City Council Special Meeting Agenda

Site Plan Review and Special Land Use

Site: 18411 W. 14 Mile Road
Applicant: Engineering Services, Inc.
Plan Date: March 15, 2022
Zoning: O Office District
Parcel ID: 24-14-226-048
Proposal: Special Land Use

Planned Unit Development – Panera

SCALE	SHEET No.
NOTED	A-03

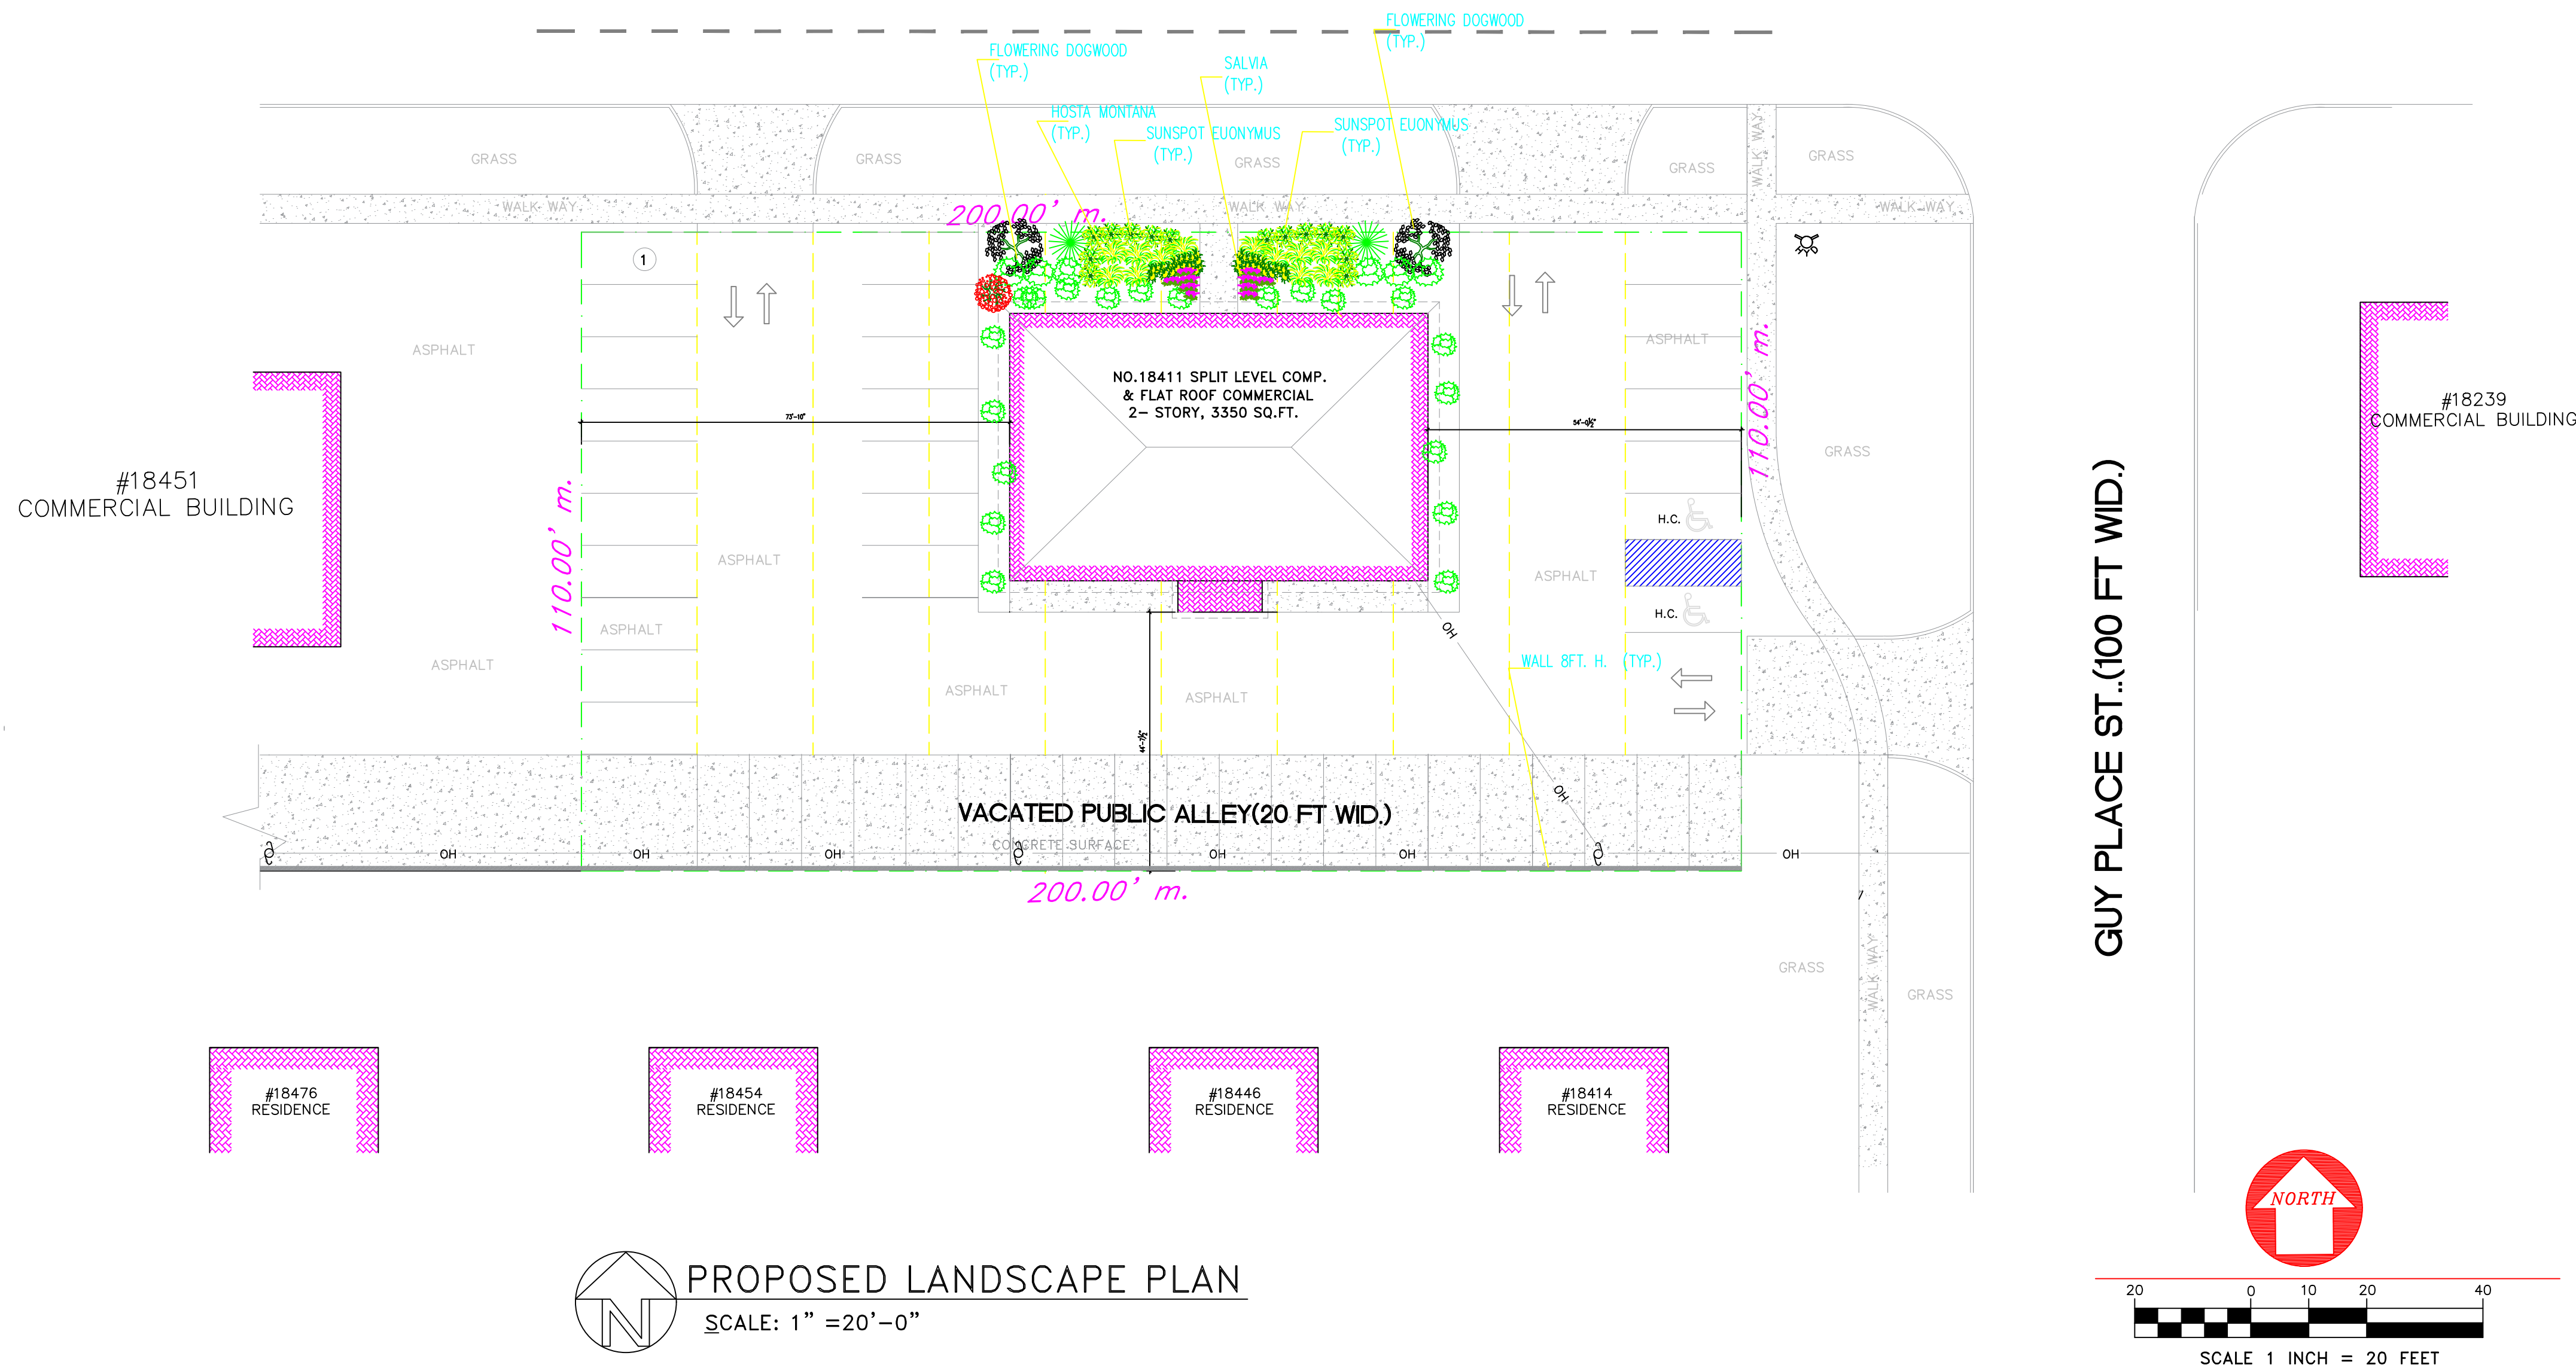
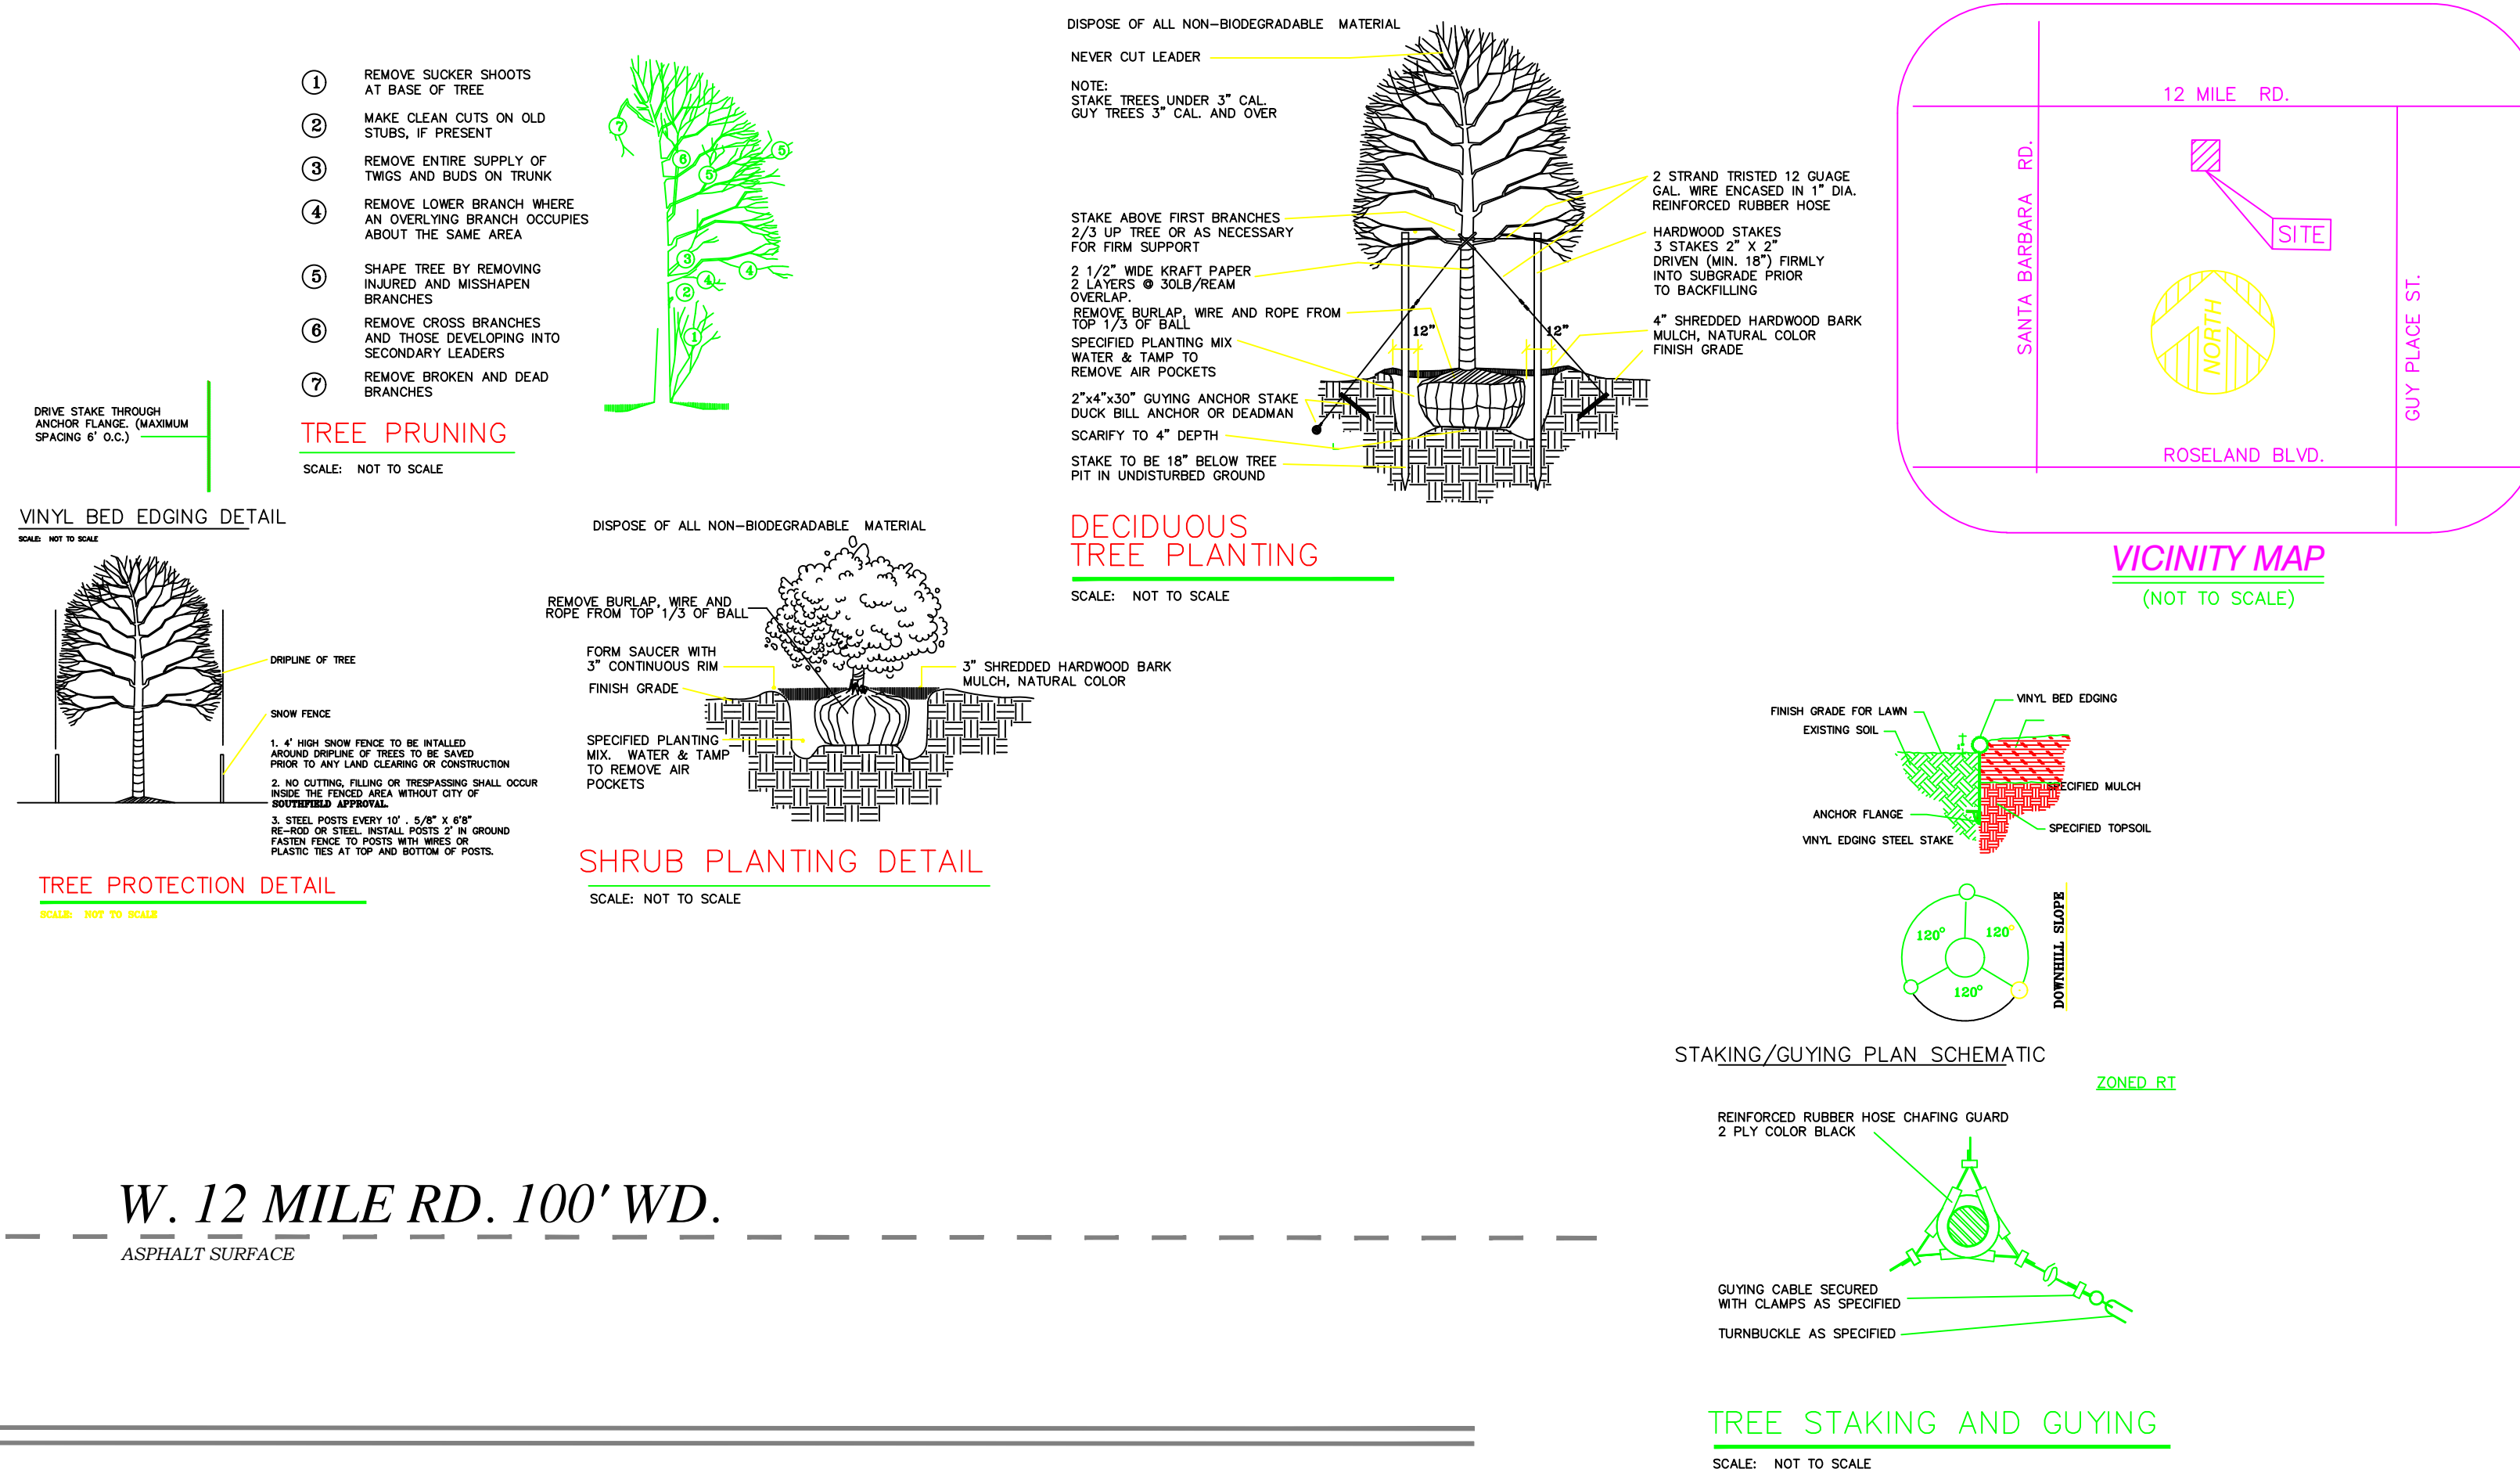
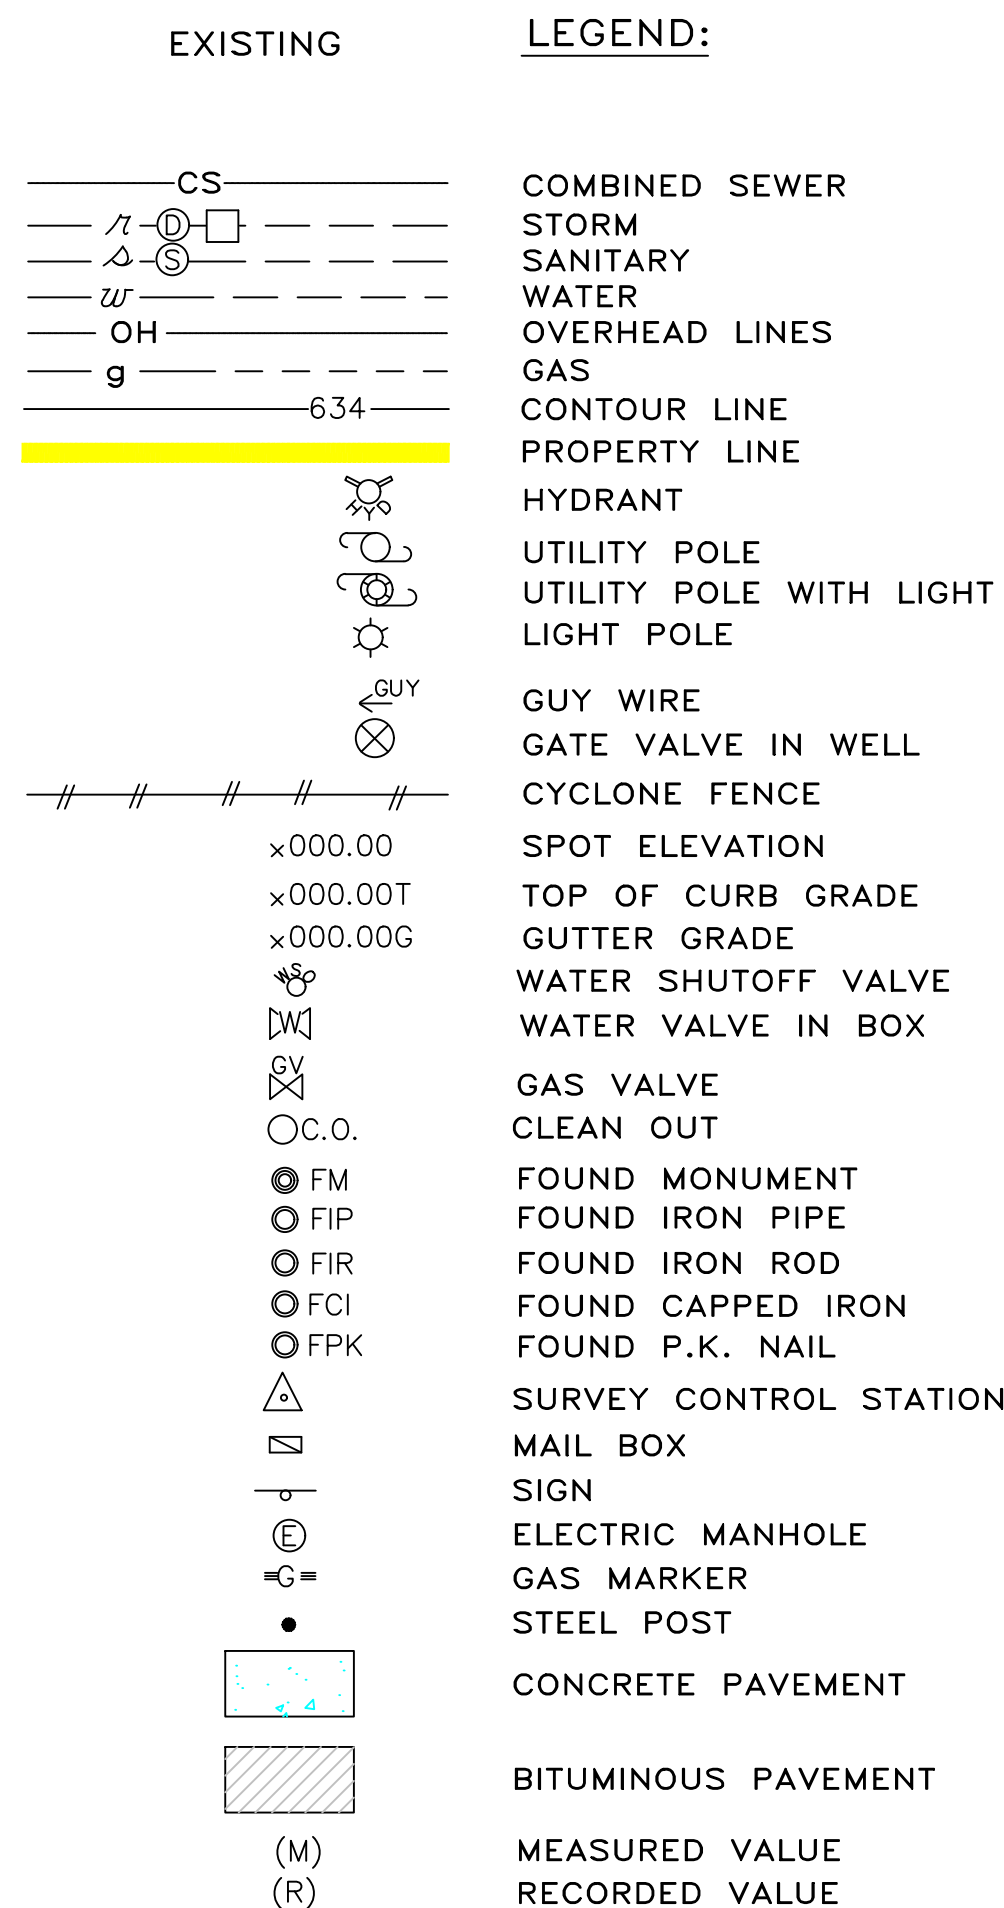
9. **Landscaping (Section 5.15).** Landscape standards for properties in the Office District are as follows:
Landscape Plan – ***A landscape plan was found on Sheet A-03 showing all proposed trees, shrubs, and perennials. The landscaped area between the building and right-of-way, as well as the sides of the building, appear to be at least 5% of the property that is required to be landscaped. Two evergreen, and two deciduous trees are planted along the landscaped buffer area in front of the building, as required by this section.***

- a. There must be provided and maintained a minimum of 15 square feet of landscaping conforming to the specifications of this article for each parking space provided in the parking facility area with a minimum of 150 square feet on any lot. ***The applicant should confirm the location of the parking lot landscaping. 15 square feet x 44 parking spaces = 660 square feet of landscaping required. From an aerial image of the site, it appears that there are two existing parking spaces within the Guy Place right-of-way that are not shown on the site plan. If the applicant does not believe these spaces are needed, and City Council approves a reduction in parking, the Planning Commission may wish to discuss whether this area could be used as a landscape area.***

- b. Parking facility landscaping shall be not less than three feet in any single dimension and not less than 150 square feet in any single area and shall be protected from parking areas with curbing or other permanent means to prevent automobile encroachment onto the landscaping areas. Areas less than these minimum requirements will not be considered as part of the landscaping requirements. ***If the landscaping on the sides of the building is intended for parking facility landscaping, dimension the width of the planting strip. Also, identify the curb or protection mechanism from the adjacent parking spaces.***

- c. A minimum of one deciduous or large evergreen tree shall be planted for each 400 square feet or fraction thereof of required parking facility landscape area. ***660 square feet of parking facility landscaping is required. Therefore, identify the one tree intended to meet this requirement.***
